UNITED STATES PATENT AND TRADEMARK OFFICE

09/973,133

Shunpei Yamazaki

Office Action Summary

FIG. 1B

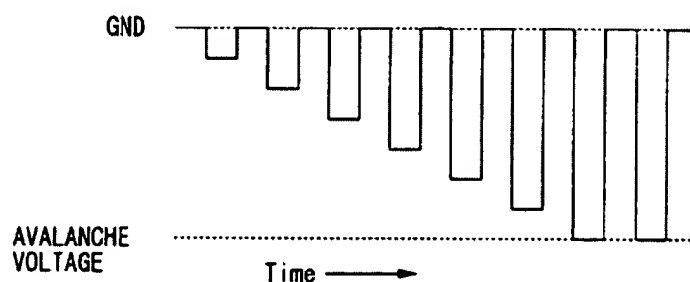
Claims 9, 17, 33, 37, and 41 recite the limitation “a first voltage and a second voltage are **alternatively** applied between the anode and the cathode.” However, there is no support for “**alternative application**” of first and second voltages in the specification or the drawings as originally filed.

Claims 9, 17, 33, 37, and 41 recite the limitation “a difference between the first voltage and the second voltage gradually increases with time.” However, there is no support for the newly added limitation in the specification or the drawings as originally filed.

However, the examiner respectfully would like to point out (since applicants are relied on Fig. 1B for support of added claims) Fig. 1B of the instant application does not show either " a first voltage and a second voltage are **alternatively** applied between the anode and the cathode" or "a difference between the first voltage and the second voltage gradually increases with time." On the contrary, Fig. 1B of the instant application as depicted below shows the current flow between the ground and avalanche voltage.
